# WRITTEN REPRESENTATION FOR SPR EA1N and EA2 PROJECTS (DEADLINE 1)

## INTRODUCTION TO REPRESENTATIONS

**Interested Party:** C C Wheeler      **PINS Refs:** 20023840 & 20023842

**Date:** 1 November 2020

**Figure 1**

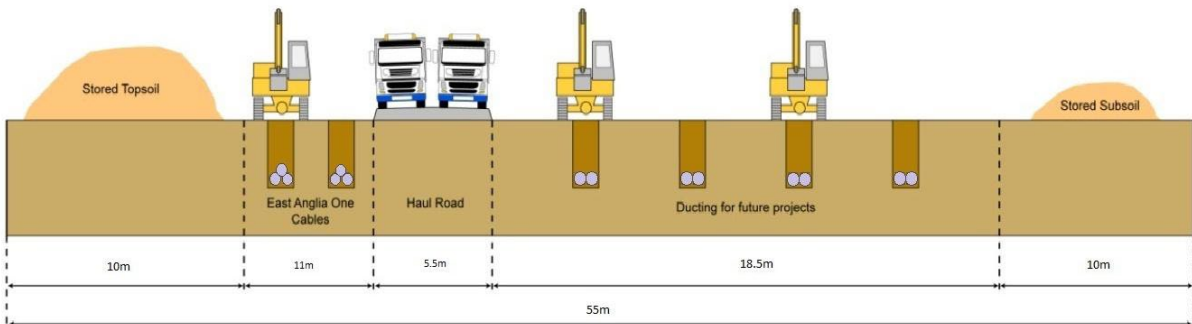
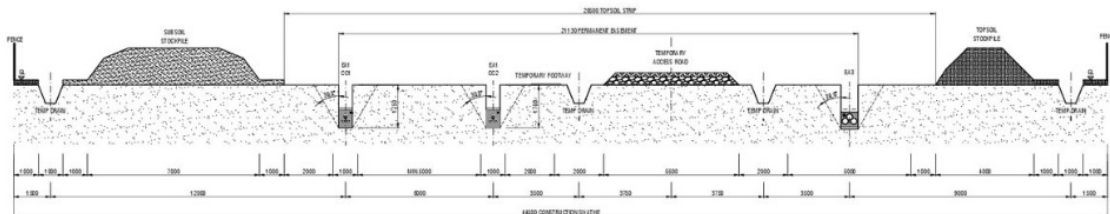
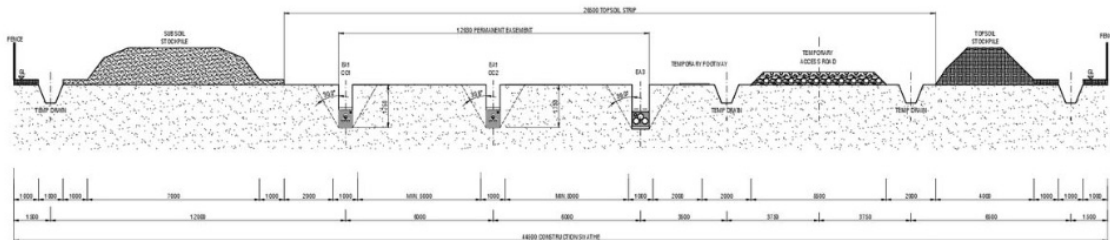
3. March 2016 However, when SPR failed to gain more than 714MW of CfD support for EA1 they argued that they should be allowed to change the transmission technology from HVDC to HVAC, resulting in a changed trench configuration and an entirely different design of onshore substation. Figure 1 shows the revised arrangement.

total of six trenches, and that only **three** trenches should be required. Again Figure 1 illustrates the effect of the change.

As Figure 1 shows, if all six trenches originally mandated by the EA1 DCO Consent had been fully utilised using Bipole HVDC at the same power level as EA3 as much as **8.4GW** (6 x 1.4GW) could have been routed to from Bawdsey to Bramford via the "Energy Motorway". Instead that has now been reduced to **2.1GW** with no objection from any party consulted. And even more bizarrely in 2016/17 SPR wished to reopen the cable route for the purposes of connecting their EA1N and EA2 projects, as evidenced by Minutes of meetings with PINS (see ~*Detail*).

1. What was originally approved in the East Anglia ONE DCO. Six cable trenches each planned to carry **600MW each** using HVDC.

2. What this changed to after approval of the technology change of HVDC to HVAC after the CfD auction which allocated only 714MW to EA1 instead of the full 1.2GW. EA1 cable trenches 1 and 2 now carry only **357MW each**. Some dimensions also changed.

3. What was eventually agreed to and built after further correspondence with BEIS. Six trenches now reduced to three, but trench 3 now carrying the whole **1.4GW** from EA3. Had all six trenches been used in this way the cable route capacity might have been **8.4GW**.

**Figure 1. Surface Water Flood Risk to NGET Substation and OHL Works**

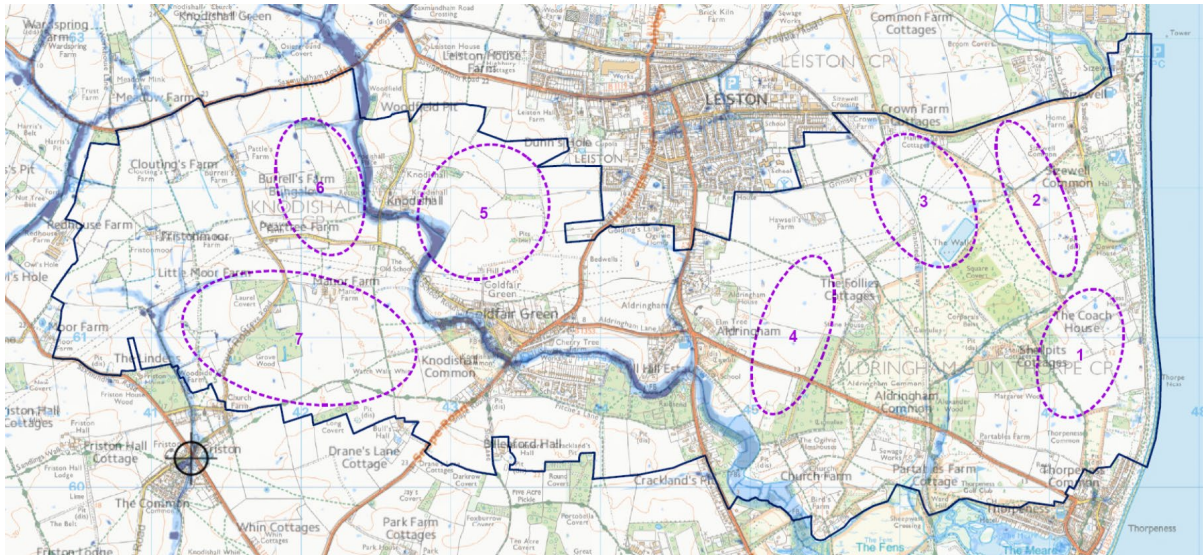
However, this wording does not seem consistent with the actual surface water flood risk shown in the Environment Agency map (see Fig. 1 below which has been assembled from Figure 20.1.2 of Ref. 4 and the OLMP plan from Ref. 5). The NGET substation is the structure on the North-West side. The required Pylon and Sealing End Compounds and structures are also shown, and also fall within the surface water flood area.

Figure 1 Sizewell Emergency Planning Zones

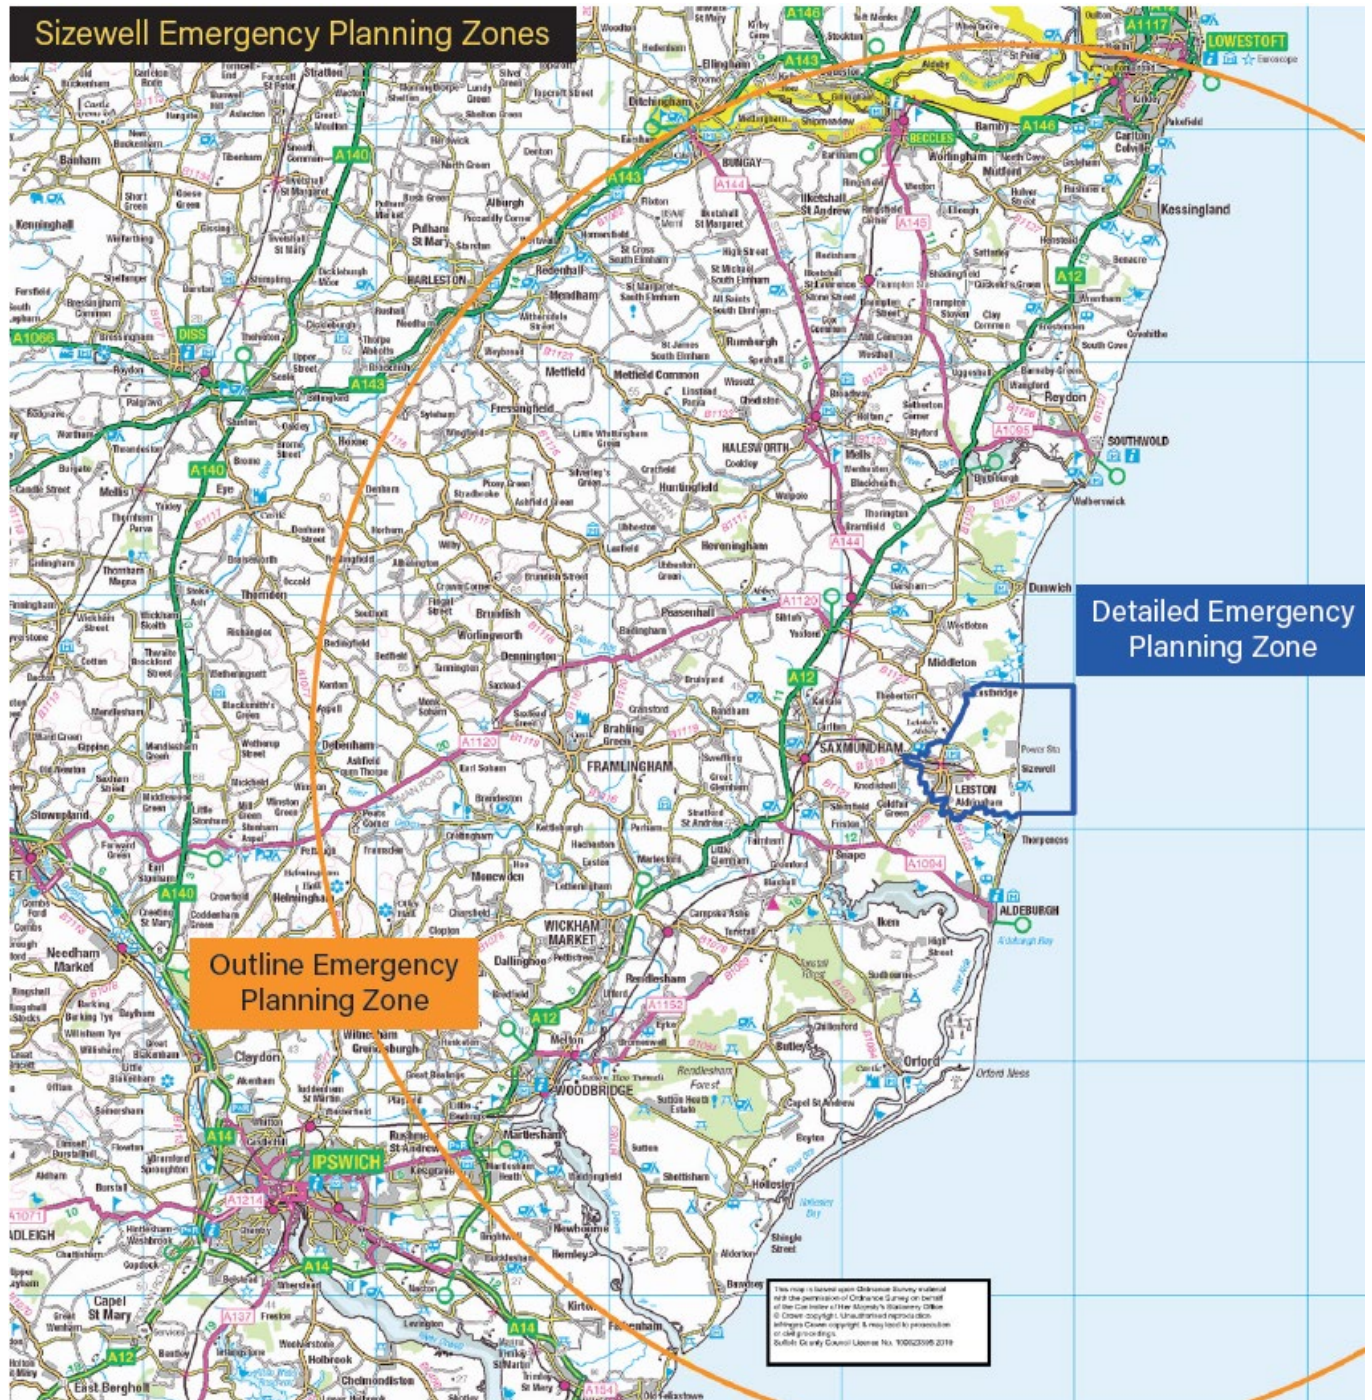
3. The Outline Emergency Planning Zone (Fig. 1 taken from Ref.1) within which evacuation might be required in the event of serious radioactive release is in the process of being extended to 30km from Sizewell. Such an evacuation, especially from the Detailed Emergency Planning Zone (Fig. 1), would inevitably rely on the road infrastructure which has a number of bottlenecks in the Leiston Saxmundham area leading to the A12, including the congested signal controlled junctions in both towns.

**Figure 1**

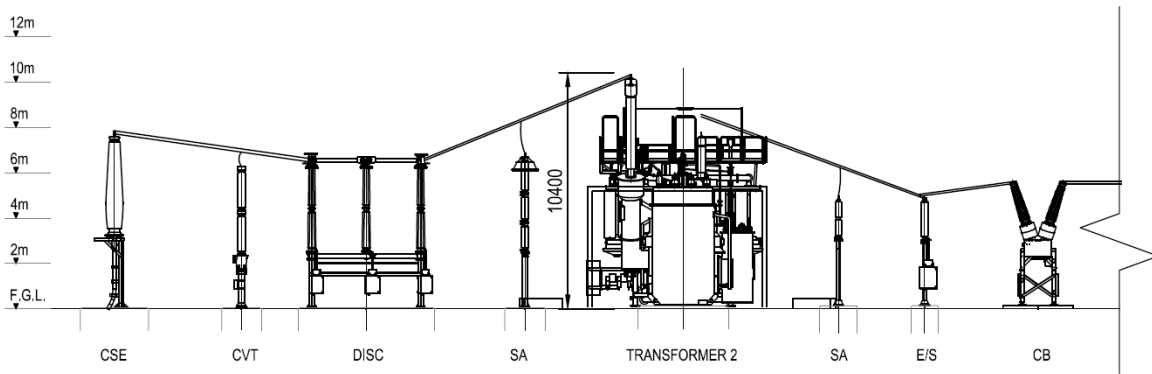
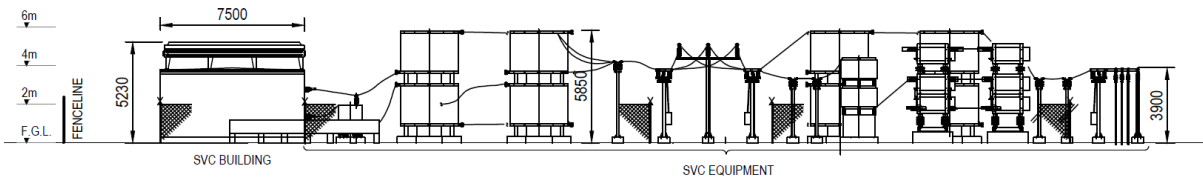
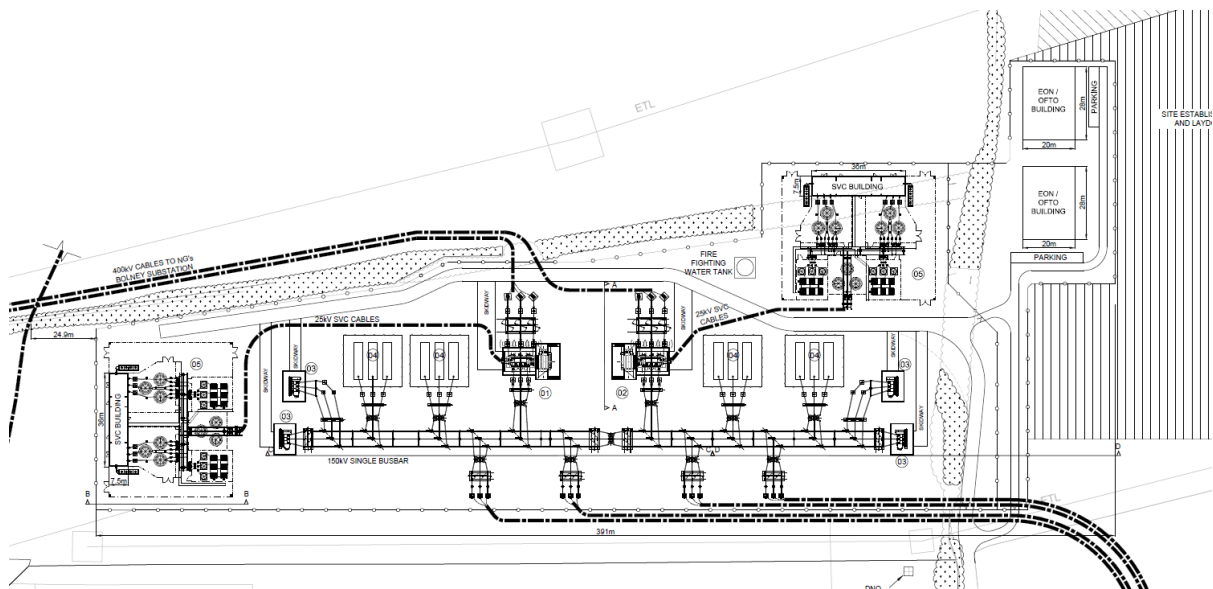
5. The design of the *Rampion* wind farm on-shore substation near to the NGET substation at Bolney, West Sussex, provides a clear challenge to what SPR are offering for EA1N and EA2. The elevation plans for this (Ref. 4 and extracts in Figs. 1 & 2) show **nothing above 8.3m** in the substation apart from the top of the Super Grid Transformer ‘horns’ at 10.5m. Everything else is nicely designed to fit below 8.3m, including the service buildings, SVC/STATCOMS etc. It is understood that this type of design is known by specialist engineering contractors as a ‘low impact’ design (Ref. 5) and it is clear from Ref. 7 that the original design was the subject of considerable improvement as a result of the Consultation and Examination process.

6. The *Rampion* substation plan area (Ref 6 and extract in Fig.3 ) appears to be about 400m x 100m compared with the 190m x 190m proposed for EA1N and EA2, **so is quite similar in area.** The designed power capability is however 700MW (as per DCO) against the 800MW / 900MW for EA1N and EA2. Also the switchgear is AIS rather than the GIS proposed by SPR, which is why the service buildings are no higher than 6m, but nevertheless it is clear that effort has been made to minimise substation overall height and visual impact.
